December 1, 1995

United States Nuclear Regulatory Commission Region I  
Attn: Mr Eric H Reber Mail Control No. 122351  
475 Allendale Road  
King of Prussia, PA 19406-1415

**SUBJECT:** Amendments to Sensor Services, Inc., application to distribute sealed sources, docket # 122351 in response to your deficiency letter dated 11-20-95.

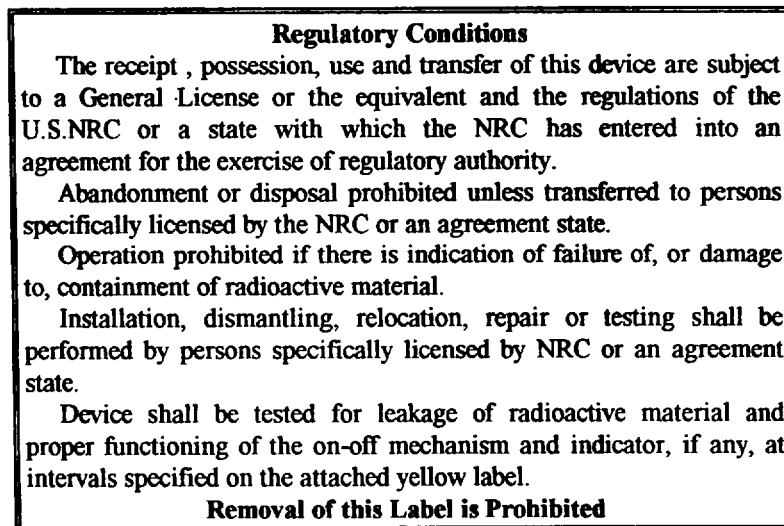
- \* Each existing AccuRay source and source housing has at least three different tags.
- \* Metal tag, approximately 3" X 1 2/2" stating:

**NOTE:** The exact wording may vary depending on when the tag was issued.

This tag is riveted to the bottom of the actual source holder and can only be seen by disassembly of the source housing side covers.

**THIS TAG WOULD REMAIN.** If missing, it would be replaced.
